Job Sheet 208097

Part Name: 206A/B/L-Series Cable Cutter System, High

APICAL INDUSTRIES, INC.	ENGINEERING CHANGE NOTICE NO. 03047				SHEET 1 OF 1	
	DWG NO. 646.9500		REV: NC	PREPARED BY J. JACKSON	DATE: 01/24/11	EFFECT ON DWG ☐ INC. ☒ UNINC.
	DWG TITLE: 206 CABLE CUTTERS KIT					
	APPROVED BY: ENGR <i>[Signature]</i>	MFG <i>[Signature]</i>	QC <i>[Signature]</i>	EFF: NEXT ORDER		
TRANSACTION CODES (TC): A-ADD C-CREATE R-REVISE D-DELETE	REASON: ADDED GPS MOUNT KIT, F/N 52. REVISED DRAWING VIEWS. ADDED NOTE <u>2</u> .

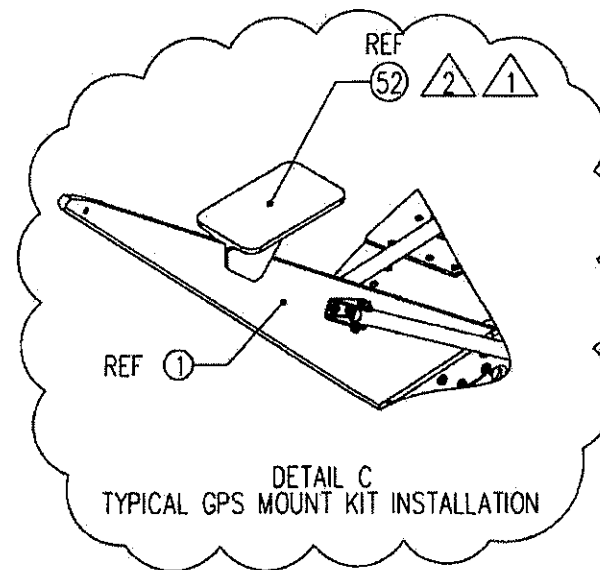
SHEET 1, ZONE B1 IS:

2 AT CUSTOMERS OPTION, INSTALL F/N 52 BY MATCH DRILLING ONTO F/N 1.

SHEET 2, ZONE A3 IS:

SHEET 2, ZONE B2 IS:

52	A	647.5701	REF	REF	GPS MOUNT KIT	<u>2</u>	
F/N	TC	PART NUMBER	QTY		DESCRIPTION	MATERIAL	SPECIFICATION
			.9502 .9501				
DOCUMENTS EFFECTED:						CHANGE CATEGORY	DER REVIEW REQUIRED
☐ MDL ☐ INSTALL INSTRU ☐ ICA ☒ BOM						☐ MAJOR ☒ MINOR	☐ YES ☒ NO

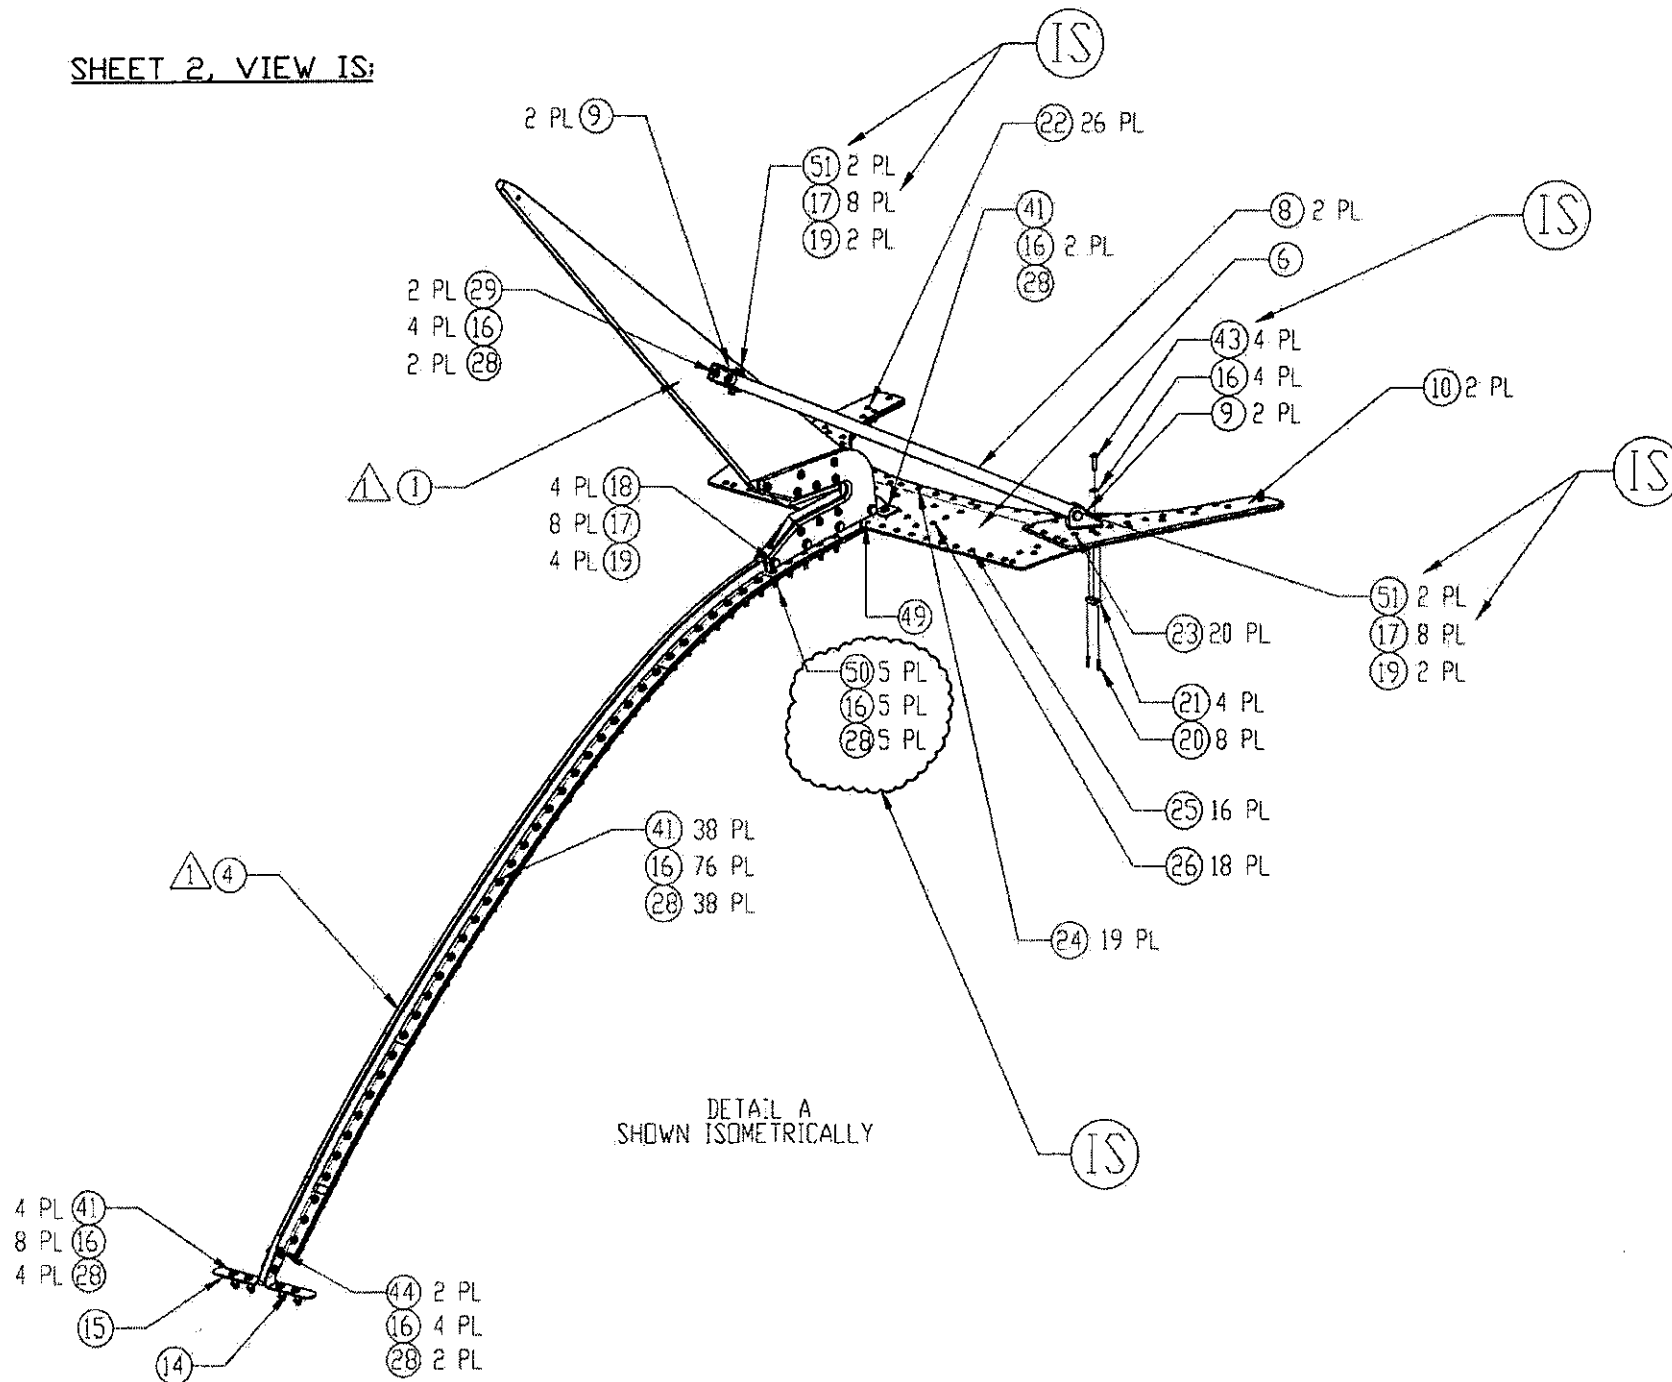
APICAL INDUSTRIES, INC.	ENGINEERING CHANGE NOTICE NO. 02729				SHEET 1 OF 3	
	DWG NO. 646.9500	REV: N/C	PREPARED BY S. HUFF	DATE: 12/23/09	EFFECT ON DWG ☐ INC. ☒ UNINC.	
	DWG TITLE: 206 CABLE CUTTERS KIT					
	APPROVED BY:	ENGR <i>[Signature]</i>	MFG <i>[Signature]</i>	QC <i>[Signature]</i>	EFF: CURRENT ORDER	
TRANSACTION CODES (TC) A-ADD C-CREATE R-REVISE D-DELETE	REASON: HARDWARE REVISIONS FROM FIRST INSTALL

51	A	601.3155	8	8	BOLT	AN3-10A
50	A	601.3153	5	5	SCREW	MS24694S8
41	R	601.2893	43	43	SCREW	MS27039-0811
28	R	601.2973	54	54	LOCKNUT	MS21042-08
18	R	601.2826	8	8	BOLT	AN3-11A
16	R	601.2764	127	127	WASHER	NAS1149FN832P
			9502	9501		
F/N	TC	PART NUMBER	QTY		DESCRIPTION	MATERIAL/SPECIFICATION
DOCUMENTS EFFECTED: ☐ MDL ☒ INSTALL INSTRUC ☒ ICA ☐ FMS ☒ BOM						CHANGE CATEGORY ☐ MAJOR ☒ MINOR
						DER REVIEW REQUIRED ☐ YES ☒ NO

SHEET 2, VIEW IS:
